Service Information Bulletin

SUBJECT	DATE
Diagnostics	July 2017

Publication Number / Title	Platform	Section Title	Change
DDC-SVC-MAN-0140	DT12 Transmission	SPN 521730/FMI 3	Updates to procedures.
		SPN 521730/FMI 4	
		SPN 521730/FMI 5

45801

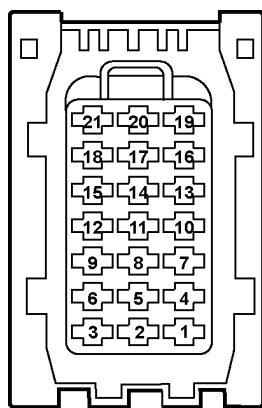
4. Measure the voltage between pins 1, 2, 3, 4, and 6 of the TCM X1 21-pin connector (ignition/battery voltage) and ground. Is voltage less than 11.5 volts?
 - a. Yes; restore voltage to pins 1, 2, 3, 4, and 6 of the TCM X1 21-pin connector.
 - b. No; Go to step 5.
5. Turn the ignition OFF.
6. Measure the resistance between pins 16, 19, 20, 21 of the TCM X1 21-pin connector and the negative battery post. Is resistance greater than three ohms?
 - a. Yes; restore battery ground to pins 16, 19, 20 and 21 of the TCM X1 21-pin connector.
 - b. No; Go to step 7.
7. Are any AMT Solenoid faults (SPNs 521736 through 521752 FMI any) also present (active or inactive)?
 - a. Yes; replace the TCM and the Automated Manual Transmission (AMT) shift control unit. Clear faults after repair.
 - b. No; replace the TCM. Clear faults after repair.
